**From:** Danny Katzman [katzman@lanl.gov]  
**Sent:** Thursday, June 28, 2007 3:16 PM  
**To:** Young, John, NMENV  
**Cc:** meverett@lanl.gov; broxton@lanl.gov; behr-andres@lanl.gov; riggs@lanl.gov; mjohansen@doeal.gov  
**Subject:** Information on R-35 and path forward  
**Attachments:** R35a062607gamma\_up\_welldesign\_email.xls

**From:** Mark Everett [meverett@lanl.gov]  
**Sent:** Thursday, June 28, 2007 4:52 PM  
**To:** Young, John, NMENV; Cobrain, Dave, NMENV; Shen, Hai, NMENV; Dale, Michael  
**Cc:** 'Danny Katzman'; behr-andres@lanl.gov; 'Jean M. Dewart'; riggs@lanl.gov; mikea@lanl.gov; spearson@lanl.gov; 'David E. Broxton'; vaniman@lanl.gov  
**Subject:** R-35b revised annular fill design approval request  
**Attachments:** Fig 1 R-35b welldesign revised 062807.pdf

**From:** Young, John, NMENV  
**Sent:** Thursday, June 28, 2007 5:37 PM  
**To:** 'Mark Everett'; Cobrain, Dave, NMENV; Shen, Hai, NMENV; Dale, Michael  
**Cc:** 'Danny Katzman'; behr-andres@lanl.gov; 'Jean M. Dewart'; riggs@lanl.gov; mikea@lanl.gov; spearson@lanl.gov; 'David E. Broxton'; vaniman@lanl.gov  
**Subject:** RE: R-35b revised annular fill design approval request

R-35a As-Built 6/26/07

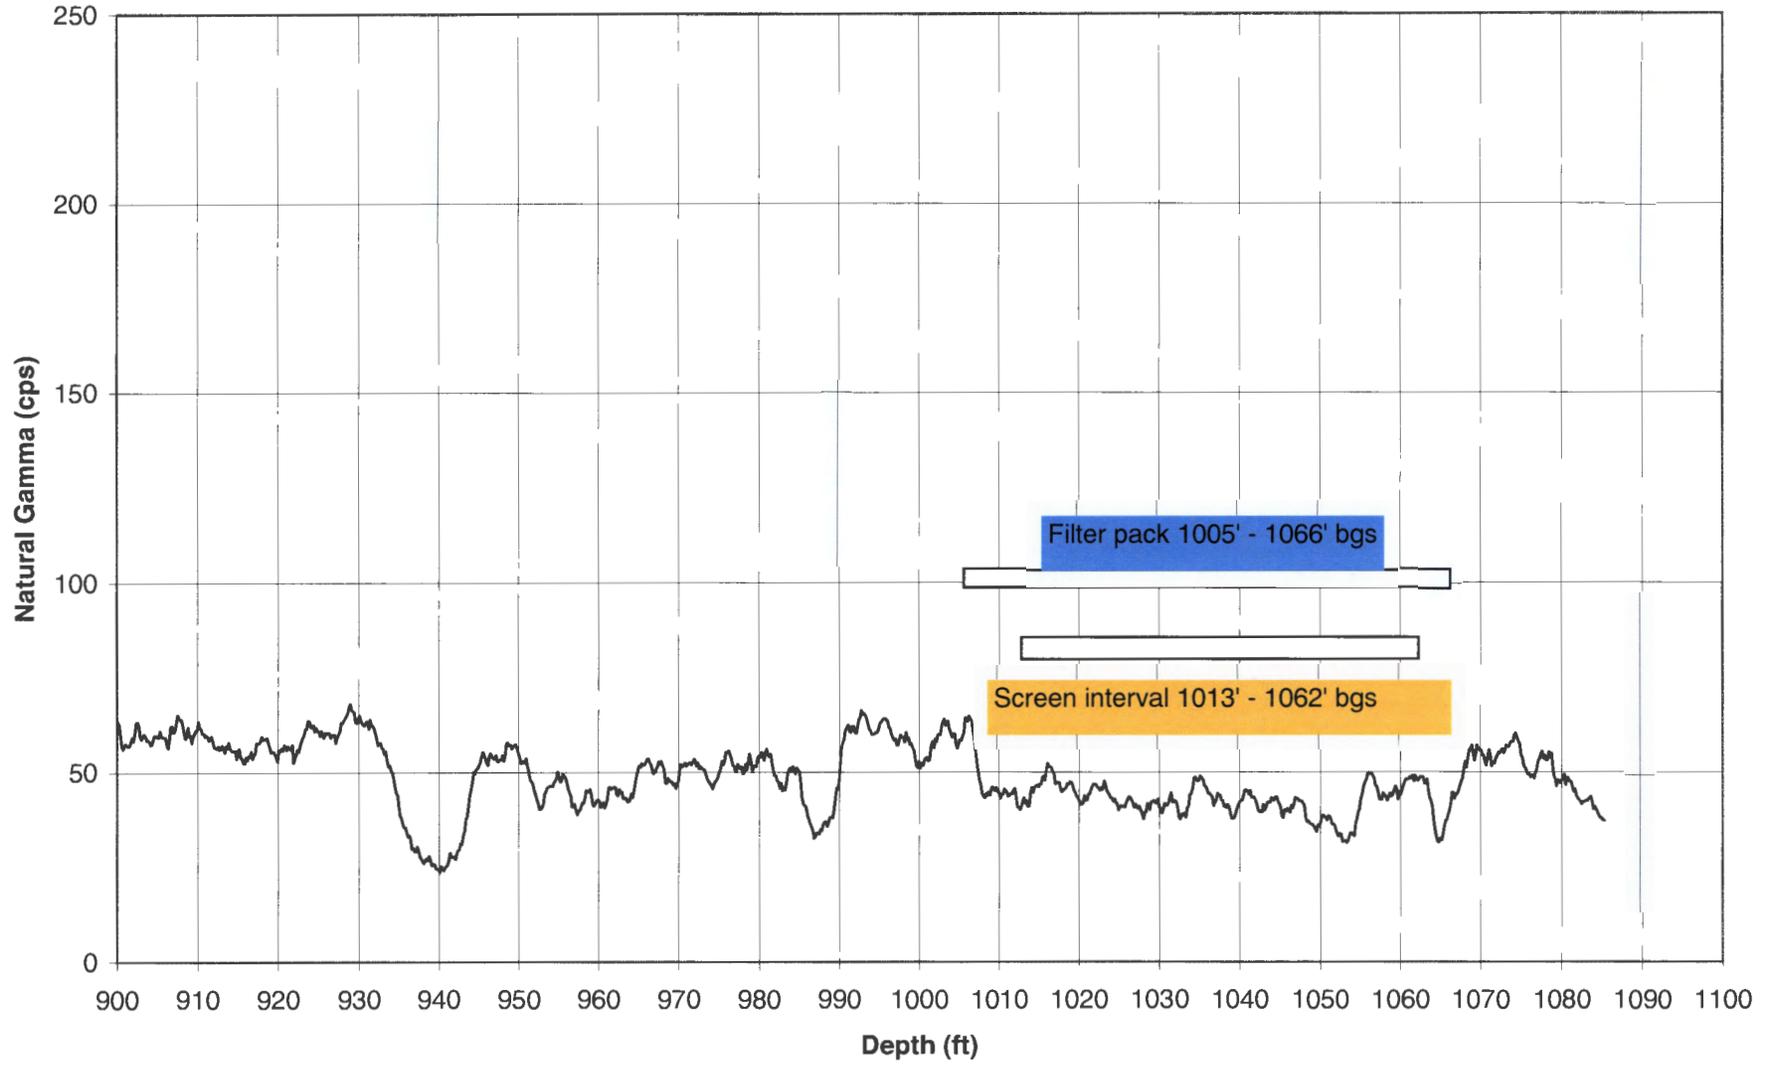
- On the June 21, LANL initiated development of Well R-35a. It was noted that the water level was approximately 150 feet above the expected static water level. At that time, a three foot zone of bentonite grout was identified in the well sump at a depth of approximately 1065 feet below the ground surface, three feet below the bottom of the screened interval.

Prior to the development activities on June 21, 2007, the water level in the well measured approximately 150 feet above the anticipated static water level, indicating that water added during construction was not rapidly equilibrating with the formation through the well screen. This observation was made prior to the introduction of any bentonite above the screened interval. Following surging and bailing, the water level in the well has returned to the anticipated static level, indicating that the well is in direct hydraulic communication with the formation.

LANL's initial analysis of the gamma log confirms the filter pack and transition seal are emplaced at the planned depths.

The video log produced usable information down to a depth of approximately 19 feet below the top of the well screen; below this depth the well water was too turbid to enable reliable observations of the well screen. The log indicates that there are no breaches in the well casing or screen, and bentonite was not observed

LANL proposes to continue development of R-35a in accordance with the Consent Order, the R-35 Drilling Plan, and standard environmental practices. Methods will include surging/swabbing, bailing, and pumping. During development

### R-35b Well Design

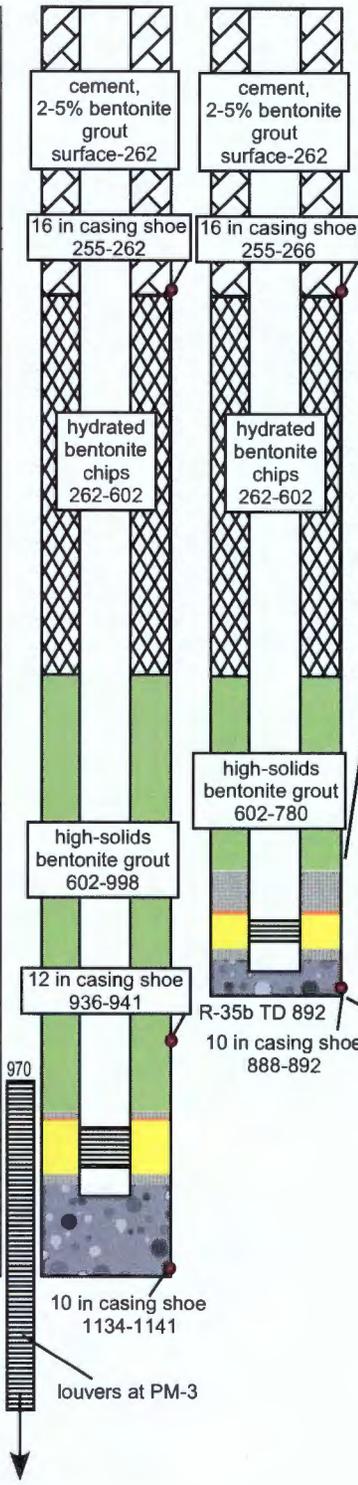
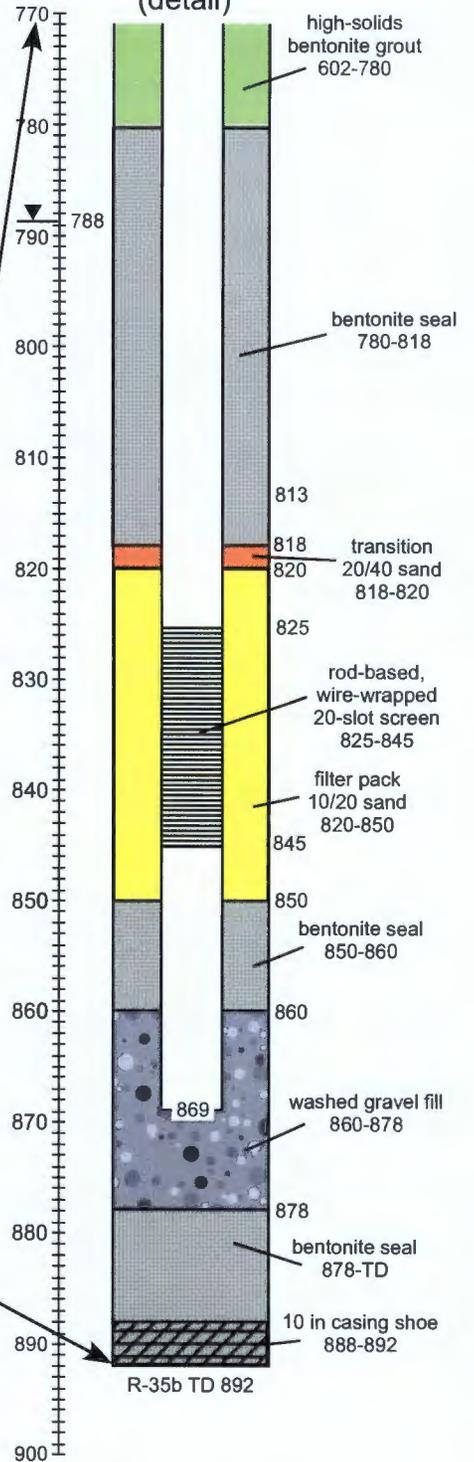
The attached annular fill design for R-35b reflects decisions made in our discussion earlier today. LANL will extend the bentonite chip seal from above the fine-grained transition sand at 818 feet to just above the top of the regional aquifer at 780 feet. A bentonite grout will be used to fill the annulus from the top of the bentonite chips to the base of the Cerros del Rio basalt at 602'. Bentonite chips will be used to fill the basalt interval by using the drill casing as the tremie pipe. The bentonite chips will be hydrated as they are emplaced and a tag line will be downhole continuously to ensure no bridges form in the annulus. If this modification to the annular fill design at R-35b is acceptable, please respond to this e-mail with your approval. If you have additional comments or questions, please call me at 231-6002.

Go ahead and construct as proposed.
